APPLICATION NO.	FILING DATE	FIRST NAMED INVENTOR	ATTORNEY DOCKET NO.	CONFIRMATION NO.
10/716,466	11/20/2003	Georges Caillon	Q78567	6848
23373	7590	05/15/2007	EXAMINER	
SUGHRUE MION, PLLC 2100 PENNSYLVANIA AVENUE, N.W. SUITE 800 WASHINGTON, DC 20037			LEWIS, BEN	
		ART UNIT		PAPER NUMBER
		1745		
		MAIL DATE	DELIVERY MODE	
		05/15/2007	PAPER

Office Action Summary	Application No.	Applicant(s)	
	10/716,466	CAILLON ET AL.	
	Examiner	Art Unit	
	Ben Lewis	1745

Detailed Action

FIG. 4B

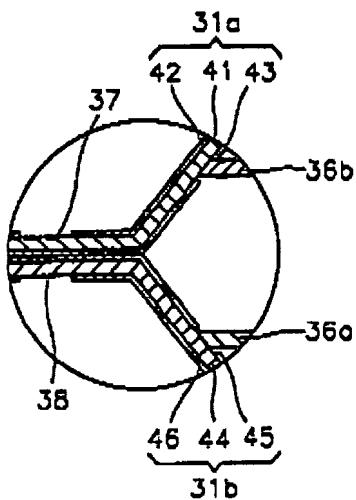
(a) and (b) Chang teach that referring to FIG. 4, each of the upper and lower case bodies 31a and 31b is comprised of a thin conductive foil 41 "terminal", such as an aluminum foil, both surfaces of which are coated with electrically insulating layers 42 "outer packaging layer", 43, 45 and 46 "outer packaging layer" made of polymer. Hereinafter, a description will be given as to an embodiment employing aluminum as conductive layer. However, the present invention is not limited to the use of aluminum but other conductive foil can be used (Col 2 lines 10-67).

"The terminals **41** and **44** come together as shown in Fig. 4B to form a single connection tab which protrude through packaging means **42** and **46** exposing surfaces **37** and **38**."
